REVIEW COMMENTS

FILE #7-94

TITLE HEADING: Site Plan Review - Glen's
Flooring

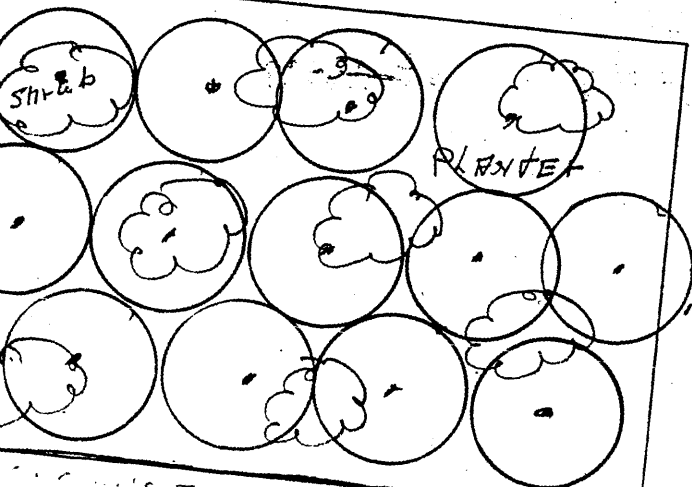
Revised okay KCA 3/16/94
still need 40% shrubs

more planter

- or viable alternative
1. Provide Hose Bib to Planter Box
 2. Provide Automatic Valve ("hose bib timer") to soaker hose or bubbler
 3. Creeping Oregon Grape Holly 3' on center - (17 min) 5 Gal size

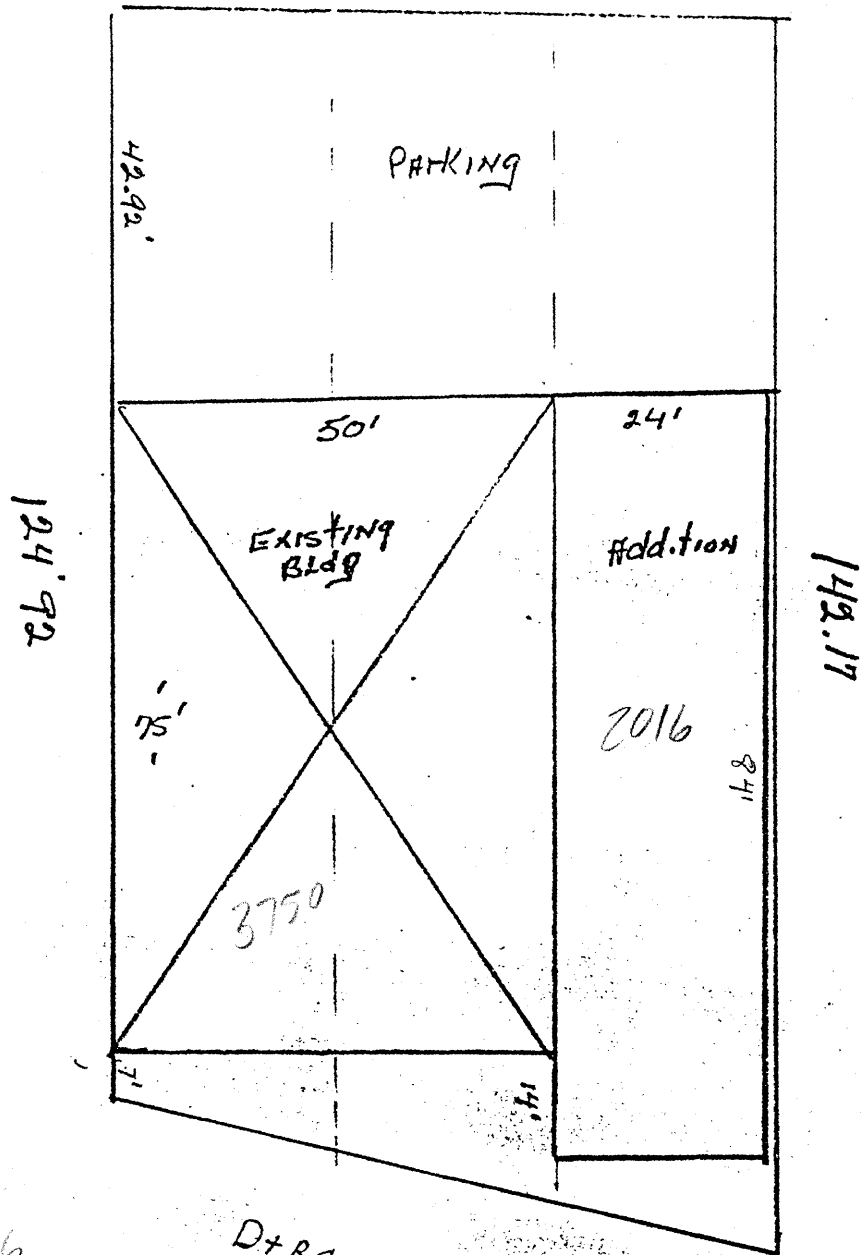
281 sq required landscaping total

35%

100 sq
